Derby Diocesan Association of Church Bellringers Consultant's Report	Report DDACB 04/08
Church of St. Giles, Killamarsh Inspection of Bells	Issue Date 13/06/08

FIG1 BELL CHAMBER LAYOUT

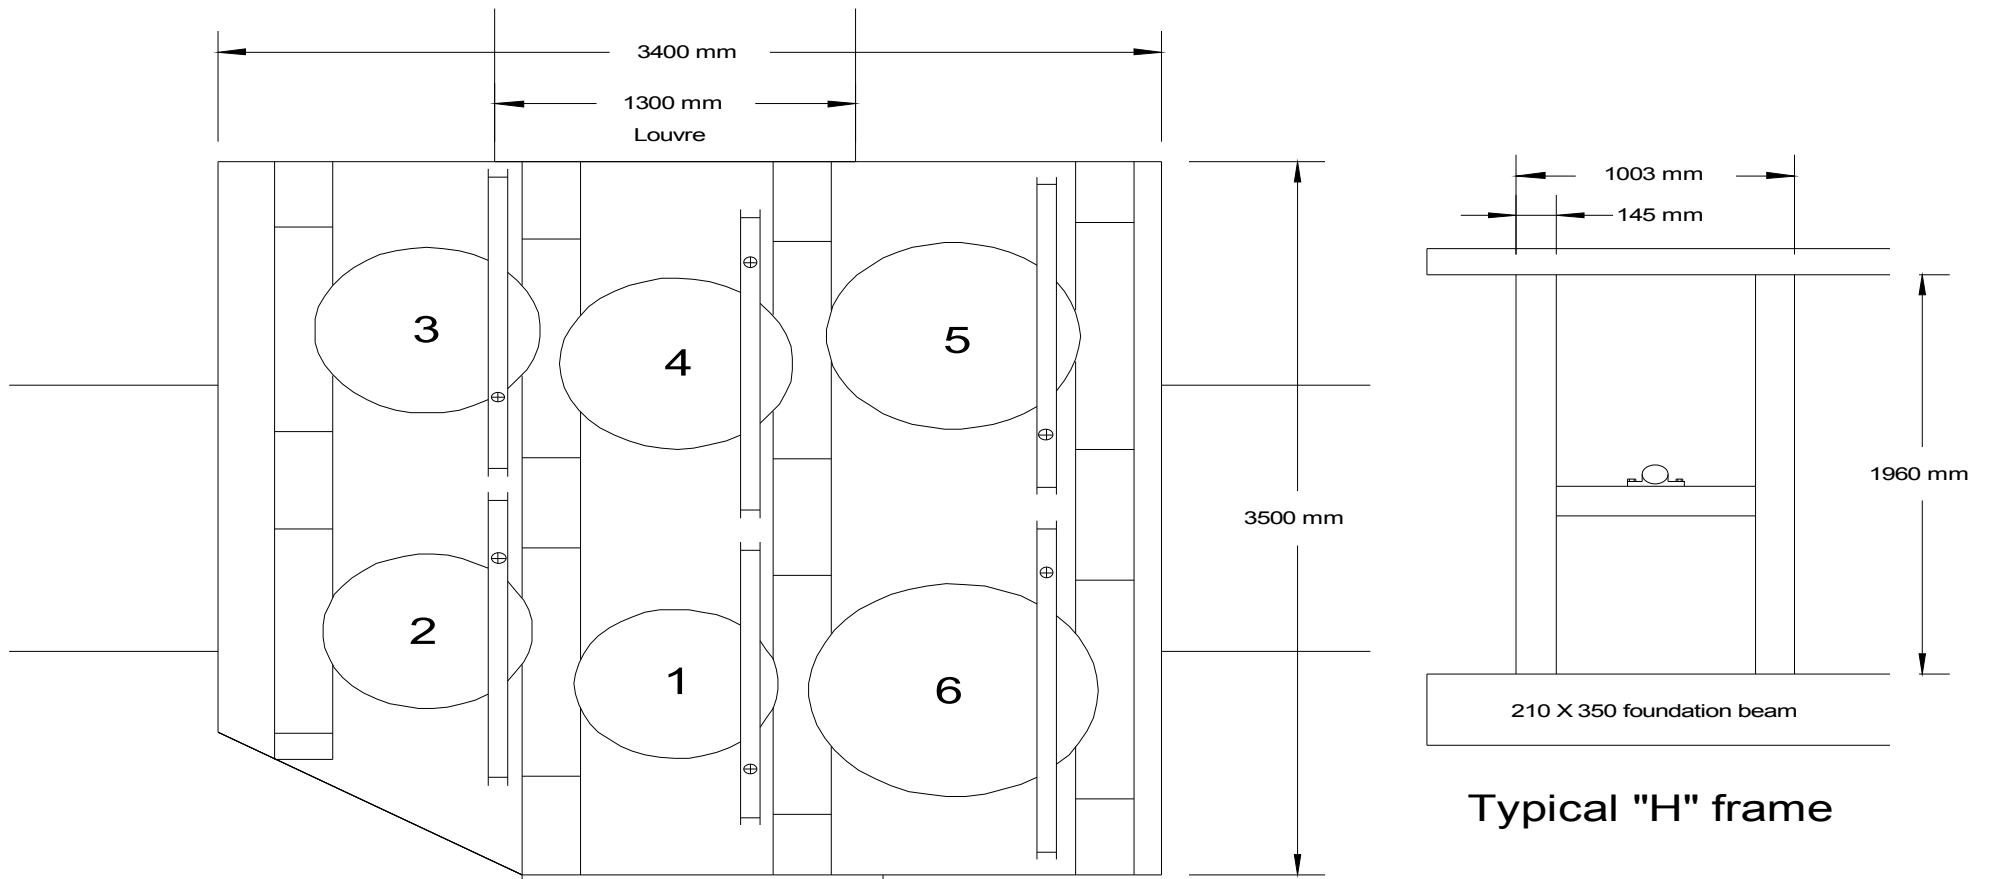
The bell chamber is reached by climbing a further 14 steps. Entry is through a doorway, where once was fitted a wooden door. This now lies against the South wall but does not interfere with the clock mechanism or ringing of the bells full circle. There is no artificial lighting fitted to the area and natural light enters through the louvres which all have wooden slat type fittings over the bottom halves. This allows birds to fly in and nest in the area. One bird was present during our inspection. Nesting material and bird droppings were noted between the walls and the foundation beams and on the screeded concrete floor. This debris retains moisture and promotes favourable conditions for the onset of rot in adjacent timbers. (It is also a health hazard). The debris should be removed and the louver openings covered in "Galebreaker" porous sheeting. This would cut down on the natural light into the area and artificial lighting would be required for fitting of muffles and any required maintenance work to be carried out safely. The wooden roof appeared to be in good condition with no sign of water ingress.

The frames are of cast iron H section securely fixed to wooden foundation beams which run North –South and are keyed into the walls with no sign of insect attack or rot. The tops of the H section cast iron frames are bolted to wooden beams which are not keyed into any of the walls. When three bells (1,2 and 3) were rung individually there was no detection of movement at lower level where the foundation beams are keyed into the walls. At the higher level there was a small amount of movement detected in the North – South line (this is the direction in which all the bells swing). We recommend that wooden wedges be driven into the gaps between the beam ends and the North and South walls to stabilise what little movement there is. All the metal work requires wire brushing and painting over.

The debris that has accumulated over the years between the walls and the foundation beams should be removed and the wood, although showing no signs of decay should be treated with wood preservative.

4. Remove all the debris from the Bell Chamber paying special attention to the areas between the walls and the wooden foundation beams.
5. Fit "Galebreaker" to cover the whole area of each louvre. This is obtainable from Mr. John Cater at a price of £15.65 metre.

6. Adjust rope position on bell 2.
7. Drive in wooden wedges between beam ends and North and South walls at upper level.
8. After the fitting of galebreaker some form of artificial light would be required to carry out any work in the bell chamber.

FIG 2 CLOCK ROOM

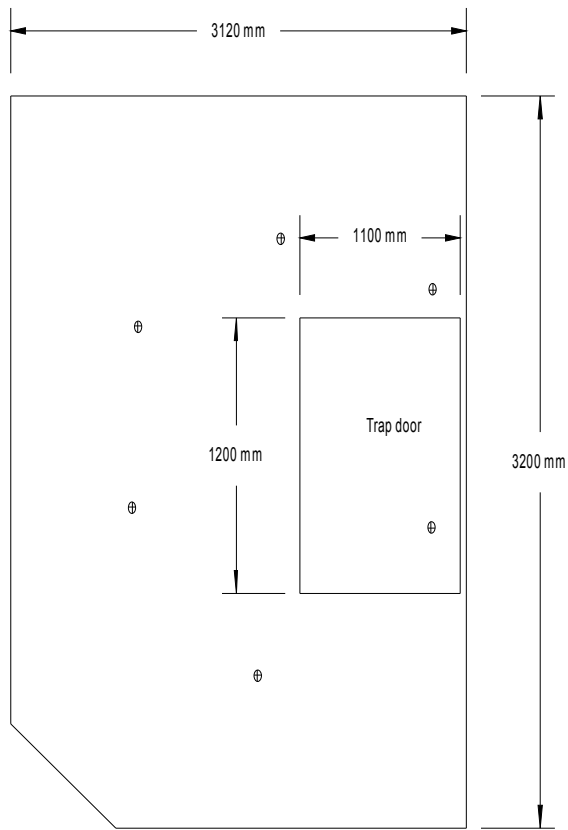
Reached by climbing 30 steps of the spiral staircase located in the South West corner. The Potts clock mechanism is well fitted and in no way interferes with any of the rope falls. The area is lit by a single incandescent bulb which gives an acceptable level of light to the area. The floor of wooden construction has a trapdoor fitted and the ceiling of wooden construction is 2450mm above the floor level. The ropes on bells 1,4, & 5 are 'drawn' and the floor pulleys

appeared to be in good condition. Bell 6 is 'drawn' slightly without the need for a pulley. The area was clean.

FIG 3 RINGING ROOM

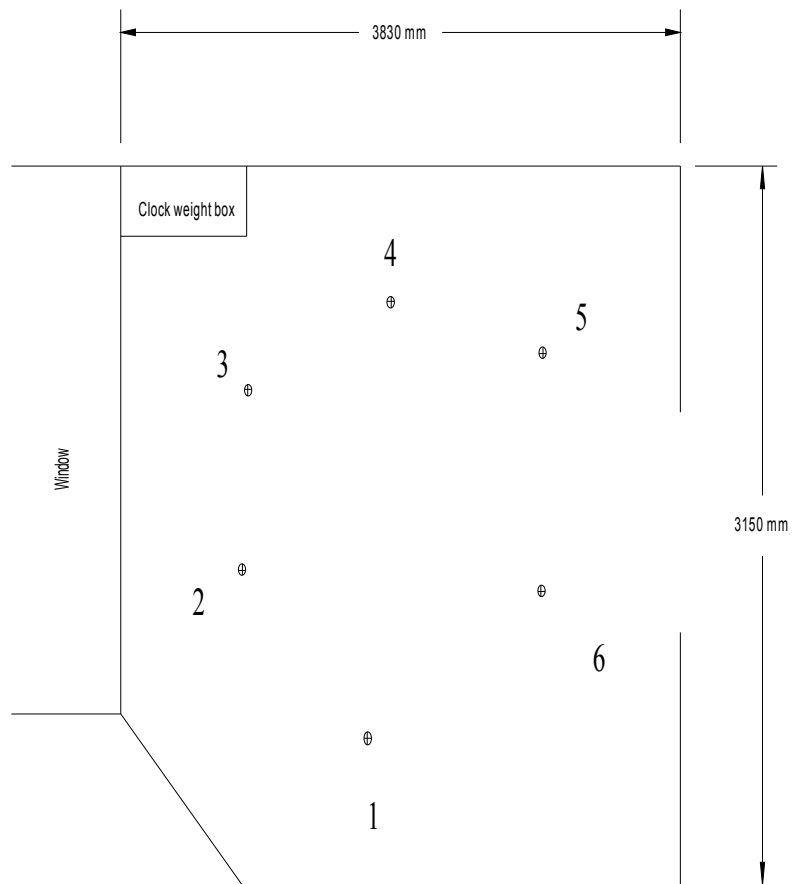
The main door to the church is located on the South wall and the ringing area is located at the West end of the church behind a wood and glass screen. The area is used for storage but this in no way affects the ringing of the six bells, the ropes of which fall in an acceptable ringing circle. Good natural light enters the area through the large window in the West wall. The wooden ceiling is 6 metres above the floor level. A rope guide frame, to which is fitted a single fluorescent light, is positioned 1500mm below the ceiling. This height is safe in the event of a ringer being carried up following the breaking of a stay. Clock hammers are fitted to strike bell numbers 1,2,3 and 6 and the hold off mechanisms are located on the North and South walls and very positive.

DIAGRAM 1
 NOT TO SCALE

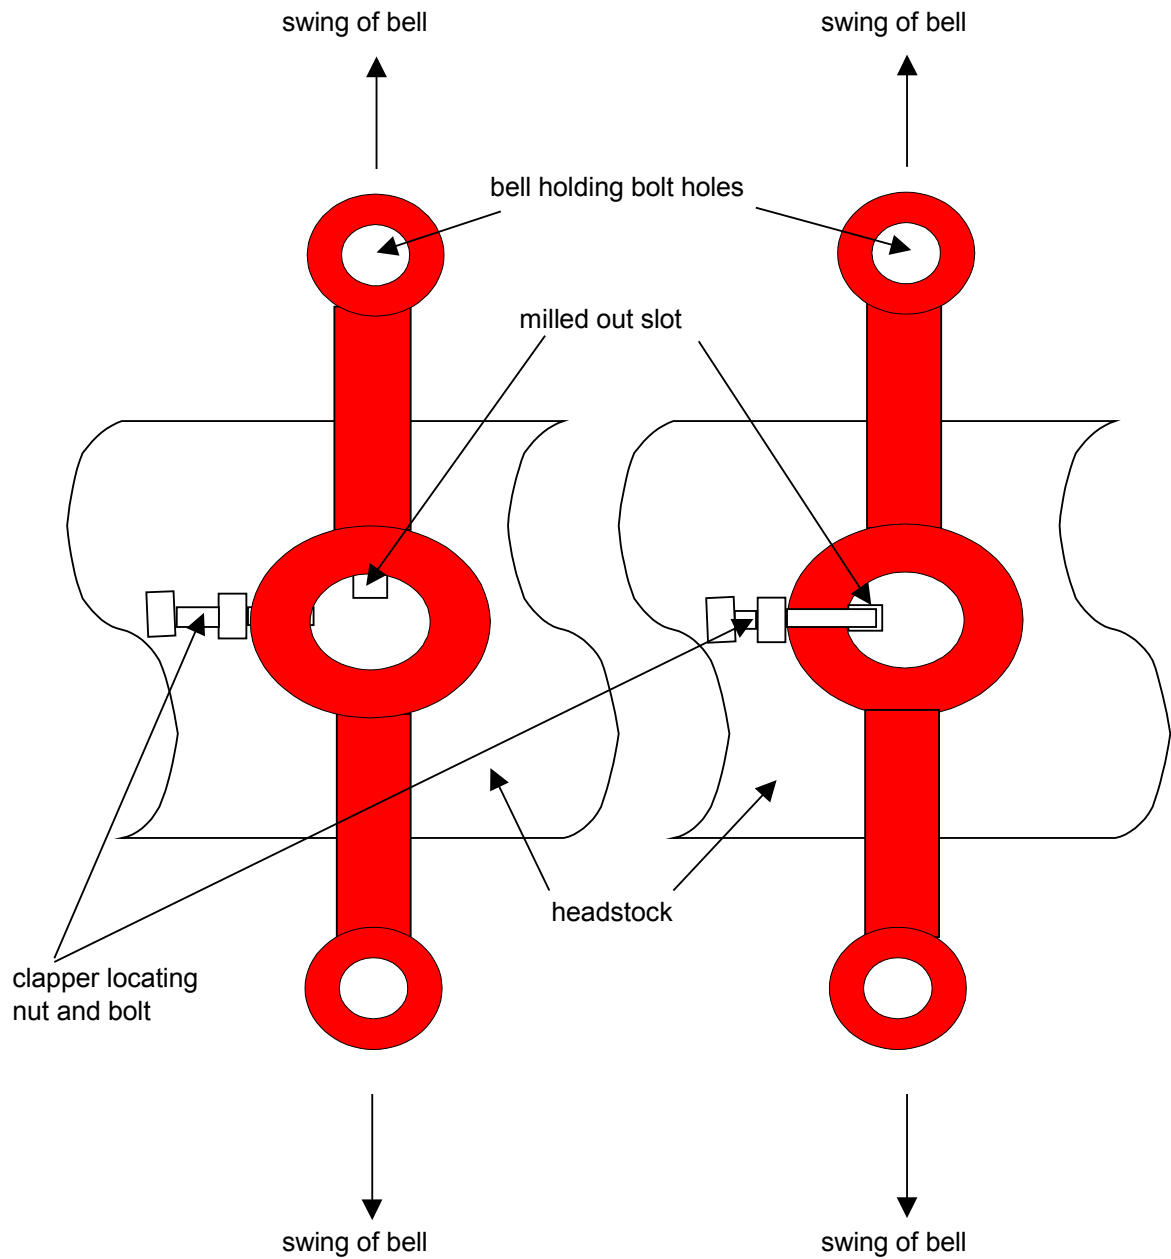
It was however possible to 'rotate' the clappers on bells 1,2,3, and 4 through 360 degrees. Even though all the clappers appeared to be swinging in the correct line (at 90 degrees to a line drawn through the centre line of both bearings) this situation is unacceptable and all the clappers should be removed and refurbished. It is thought that initially when the bells were rehung the leather washer fitted between the clapper assembly and the head of the bell created enough friction to stop this happening. Over the years the leather washers have deteriorated and dropped out leaving the clapper free to swing over a wider arc. There appears to have been a manufacturing problem as the clapper locating nut and bolt is tightening down onto the round section of the crown staple and not locating in the milled out section designed for the purpose of stopping the clapper rotating. (see diagram 1).

LEFT HAND SHOWS SET UP AS AT PRESENT which is **WRONG**
 clapper assembly location is only held in place by end of locating bolt on threaded section of crown staple.

1. All the clappers should be removed and new crown staples fitted with the clapper locating groove milled in the same plane as the clapper locating nut and bolt.

RIGHT HAND SHOWS CORRECT INSTALLATION
 clapper assembly cannot rotate due to being 'held in place' by locating bolt
